Change tolerance of pins length

Product Change Notification					PCN FMAB-72 Family - Pins lenght		
owner	creation date	release date	released by	change order no	rev	page	D40 004 007
segatro	13.12.2017	13.12.2017	stornifa	2014362	В	1 of 1	D10-021-337

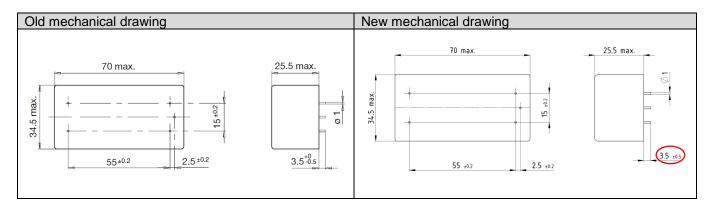
Tolerance of pins length from 3.5 +0/-0.5 to 3.5 +/-0.5.

· Previously indicated tolerances not accurate enough.
